Notice No. 2
02 March 2026

PRE-PROPOSAL QUESTIONS & ANSWERS

RFP N62742-26-R-1300
WON 1665555, FY24 AJJY183012 (P-012), PDI: NORTH AIRCRAFT PARKING RAMP,
ANDERSEN AIR FORCE BASE, GUAM

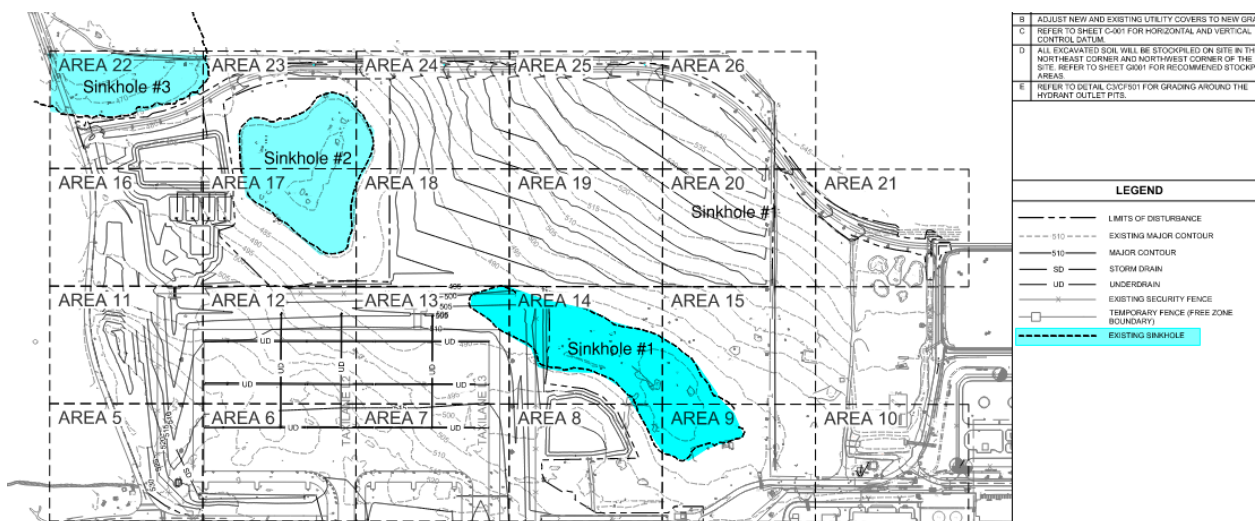
3. Section 01 57 19 page 13, paragraph 1.5.3 states that there are sinkholes present in the vicinity of the project site. ...and Obtain Class V Underground Injection Control (UIC) Permits for three (3) existing sinkholes.

However, Drawing Sheet V-101/Overall Existing Condition/Appendix A (Figure 3- Known PFAS Release Areas)- shows only two (2) existing sinkholes within the site. Please clarify.

ANSWER: Refer to CG101. A screenshot is presented in the response.

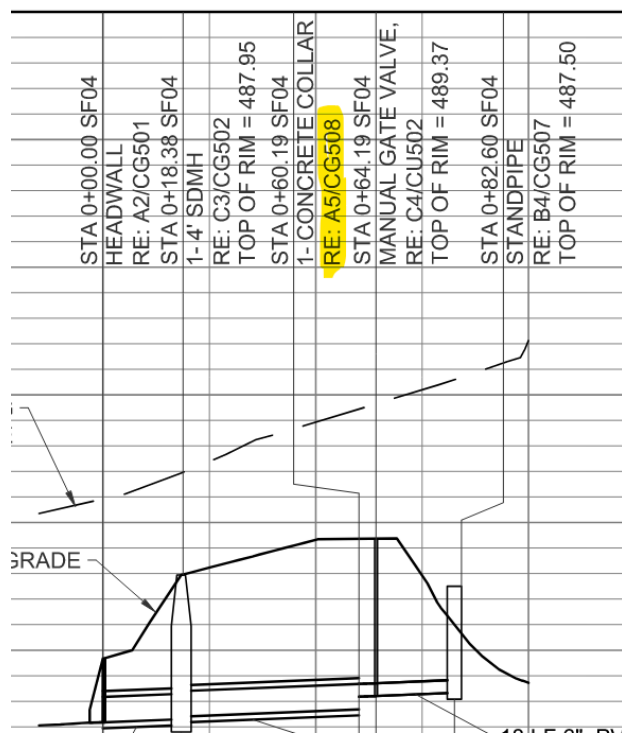
9. Drawing CG203 indicates a detail reference to Drawing CG508. However, CG508 is not included in the RFP drawing package provided to bidders. The absence of this sheet prevents a complete understanding of the referenced detail and may affect quantity take-off and bid accuracy.

Please provide Drawing CG508 to ensure accurate interpretation of the scope of work and proper preparation of the bid.

ANSWER: An amendment will correct the sheet number to CG507. The highlighted text in the image below will be amended to CG507. Amendment forthcoming.
